(NEW) Q+A QUESTIONS + ANSWERS – Questions submitted through September 25, 2026

(Prior) Q+A QUESTIONS + ANSWERS – Questions submitted through September 23, 2026

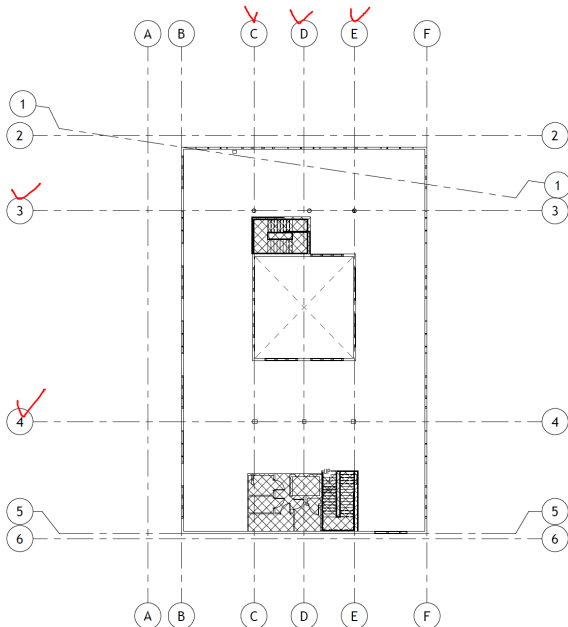
Q: Thank you for referring me back to your September 14 email. I now understand that **A is the designated main entry into NEXT** and that **B represents architectural swinging gates providing access to the interior courtyard without entering NEXT.**

If B provides independent access from the exterior to the interior courtyard without passing through NEXT, could you please clarify the **physical circulation path from B to the courtyard**? On the plan, we cannot identify a corridor, passage, or opening connecting the east exterior side at B to the courtyard.

1. the exterior → B gate → courtyard circulation route; and
2. the main entry at A, since Steelcase has confirmed that A is the NEXT entry but the actual door/opening is difficult to identify on the supplied floor plan.

A: Regarding the courtyard access and the circulation, the area highlighted in yellow is the open air courtyard that can be accessed through the gates that were identified in location (B) as shown on the published Q+A. The area highlighted in green is the interior space of NEXT on the first floor. This shows that a person could enter/exit the courtyard through the gates without entering the interior of NEXT. Regarding your question about access from the east side, please note that the door shown with the red circle is a door that enters the courtyard as well as numerous sliding doors around the perimeter of the courtyard.

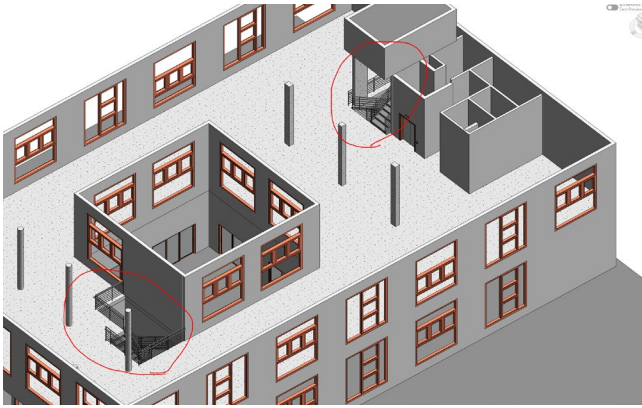
Q: Stair Enclosure vs. Provided 3D Model: in the previous Q&A, it was noted: "the assumption is that these are already enclosed for fire-rated egress as a base building as well as these areas are within the NIC areas." However, as shown in the attached 3D model, both existing stairs are currently modeled as open.

1. Question: Could you clarify if the students are expected to design the fire-rated enclosure for these stairs within their scope, or should we instruct them to assume these are completely enclosed by the base building design?

A: It appears from your drawings shown from the revit files provided that these are not drawn as enclosed for fire-rated; therefore, we have confirmed the actual as built condition from the current occupier of this space. The stairs to the North are open. The stairs to the South are enclosed. **Under the Florida Building Code, you can leave a stairway open and unenclosed between two stories, provided specific design and sprinkler conditions are met.** Given this, our recommendations will be students can leave them as is with one open and the other closed, both open, or both enclosed. The students can choose whatever strategy best supports their design intent. The students should design a code-compliant egress strategy that meets their design intent and if this requires an additional exit door to be added or

if the path crosses outside the designated NIC boundary, this shall be permitted for this purpose as long as all codes and regulations are met.

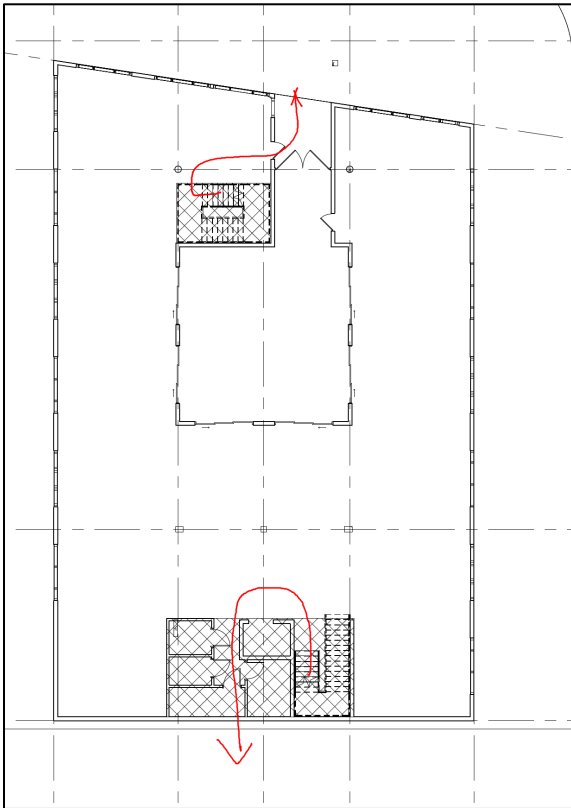
Q: Exit Discharge and NIC Boundary Conflict: if we treat these enclosed stairs strictly as Not In Contract (NIC), we run into an issue with the Exit Discharge. As illustrated in the attached floor plan, enclosing the stairs within the NIC area seems to cut off the exit discharge path to the exterior. Question: To resolve this continuous egress path, how should the students proceed? Should they design a new emergency exit/doorway to resolve the discharge? Or should they plan an egress route that crosses outside the designated NIC boundary?

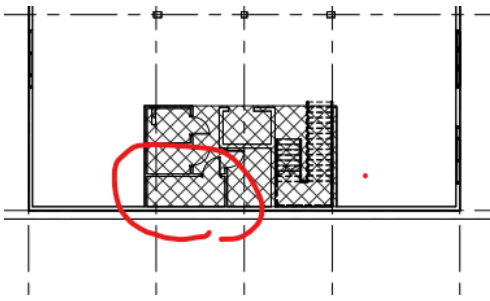
Q: Google Earth and Street View images indicate that there is an existing door on the front corner of building that opens directly onto the sidewalk. In the pdf and Revit model, this door is shown as a fixed window. For this project, are we to assume that this door has been replaced with a fixed window?

A: This is actually an exit door at the Northeast corner of the building facing Oak Ave. that was inadvertently omitted from the NEXT drawings and the location is in the Northeast Corner of the building. This door should be added back to as built condition of the site.

This shows the location based on what we received from the current occupant (see attached) as well as an image from Google of the location of the door.

REVIT floorplan and 3D

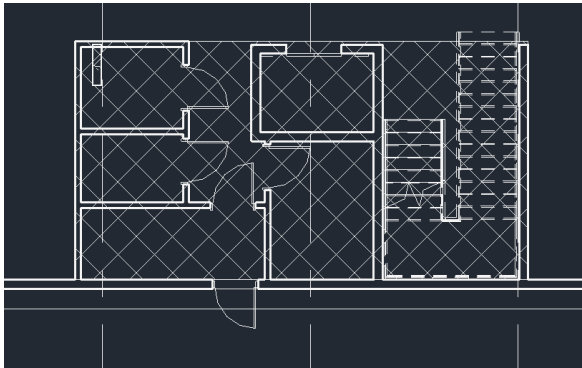
Q: In the REVIT file, on the 1st floor there appears to be an exterior door from the bathroom. Can you please confirm the accuracy of this door location? Also, this is not shown on the PDF floorplans. Please see images below.

A: Please disregard this door location as that is incorrect and should not be there. Please remove it from your plans and we will communicate that to all programs with the published Q+A.

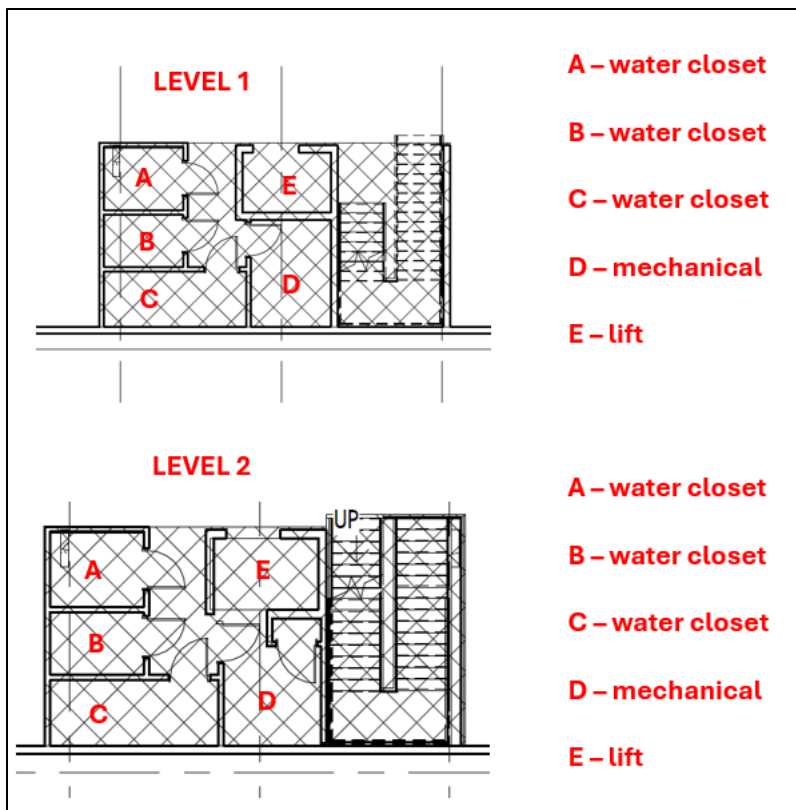
Q: In plan, there is a second door into the space beyond the courtyard gates. That door doesn't appear in photos found online of the actual building. Is that door "real" for our competition purposes and expected to remain/be used in its current location?

A: Assume the drawings are accurate for this door and it should remain.

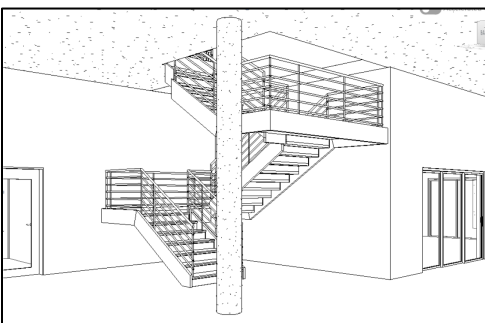
Q: There is a column on the top left of the second floor; is this correct, should it be on both floors? Attached is a screenshot of the column that is not shown between floors but only on the second.

A: We are unsure of what this is; therefore, we are suggesting it be removed from the drawings and the assumption will be made that the existing columns on grid are sufficient for structural integrity.

Front stair as provided in base Revit model:

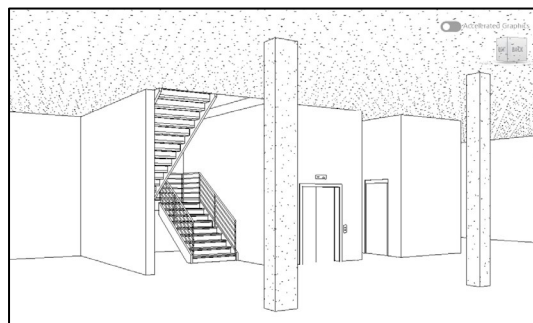
Q: Is it acceptable to enclose the existing stairs in some way? Since the front stair and rear stair are both open, some students are entertaining the thought of enclosing them in order to place greater emphasis on the required additional communicating stair. Is this acceptable? The reasoning is that multiple open stairs in the space may create confusion or appear visually cluttered.

A: The assumption should be made that the building is sprinklered appropriately throughout the building. If an exit is determined to be needed to meet code and aligns with the students egress strategy, the student may determine where to place this exit. Please note, we will be sharing information later tonight with all the Q+A and it will show there is an additional exit door on the front Northeast corner of the building that had been inadvertently eliminated and the students should add this back before determining if an additional exit door is needed for egress.
